Project Name: PEARL JUNIOR HIGH MULTIPURPOSE  
Project No: 22-056

## ADDENDUM NO. 04

1 WALL SECTION 5 (BASE BID)  
3/4" = 1'-0"

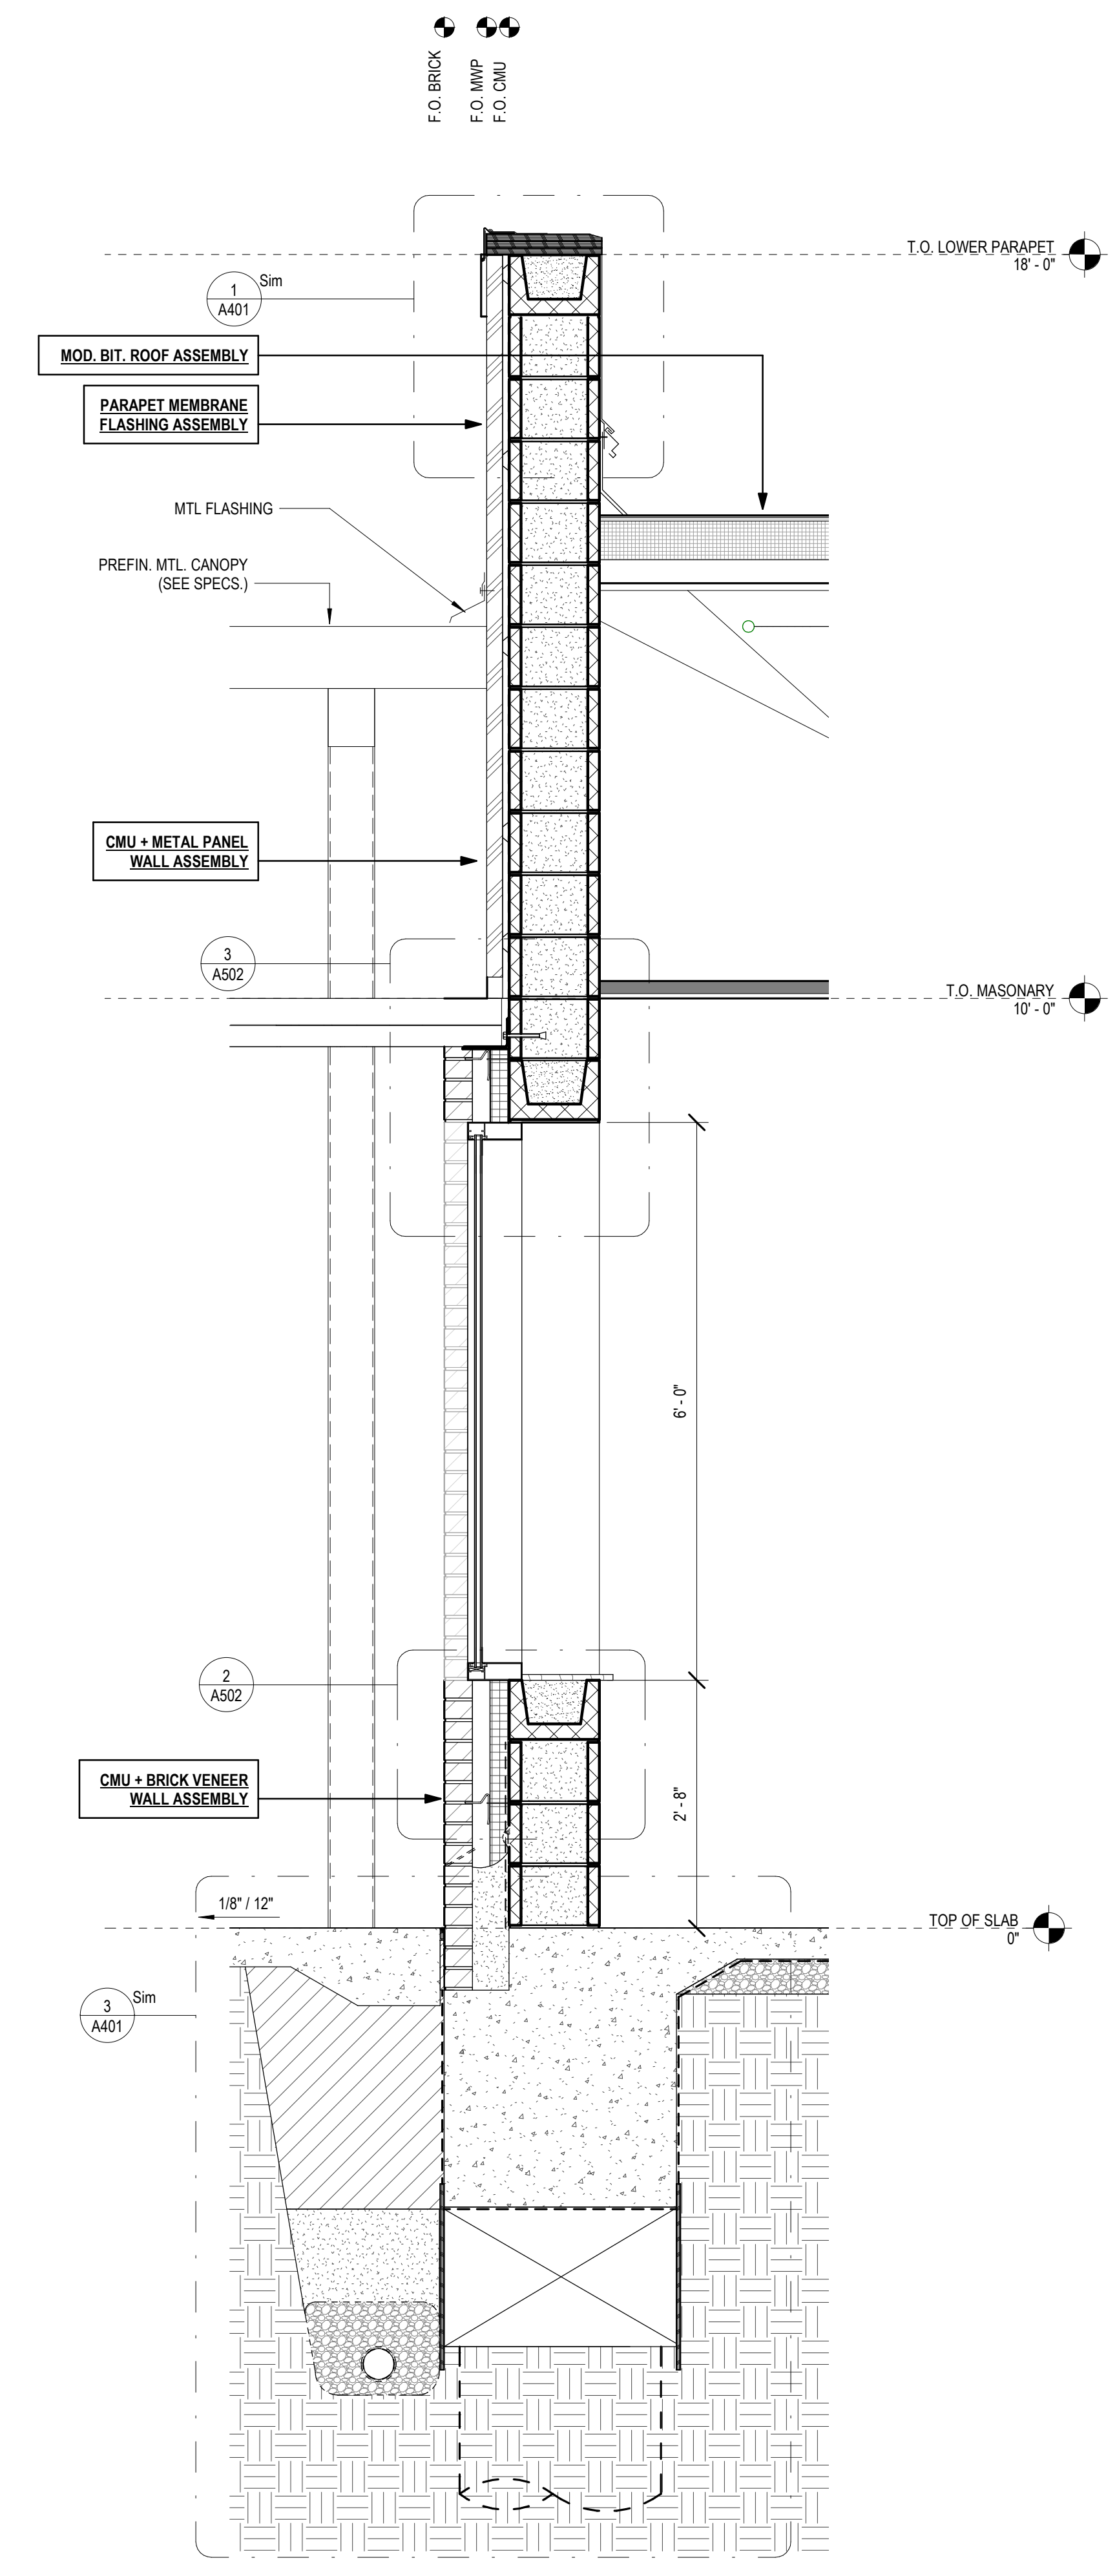
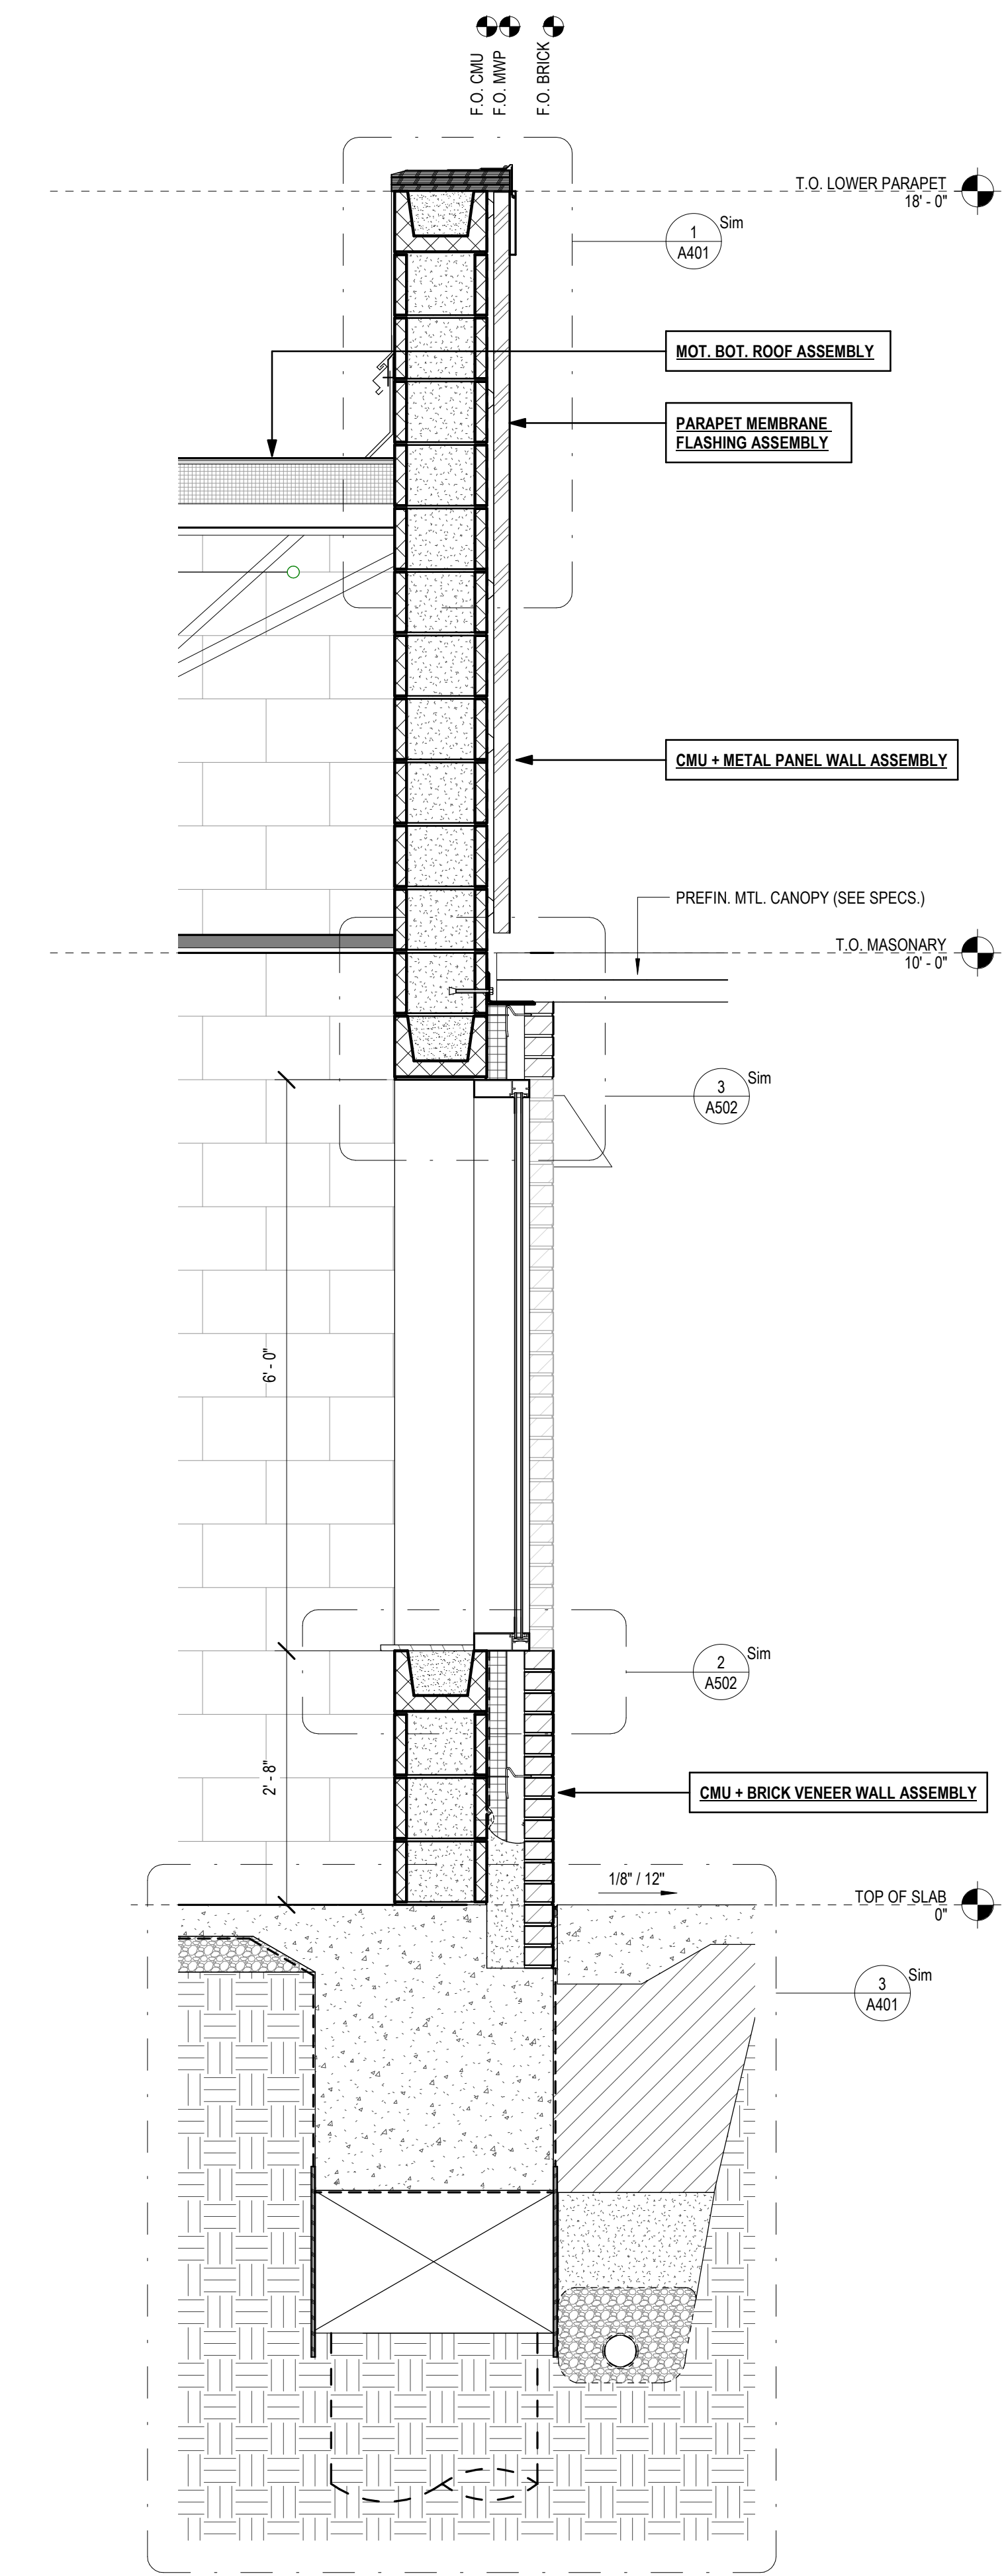
| A301 | WALL SECTIONS – BASE BID   | <ul style="list-style-type: none"><li>• Clarification of the size and elevation of the French drain around the new building.</li></ul>                  |
| A302 | WALL SECTIONS – BASE BID   | <ul style="list-style-type: none"><li>• Clarification of the size and elevation of the French drain around the new building.</li></ul>                  |
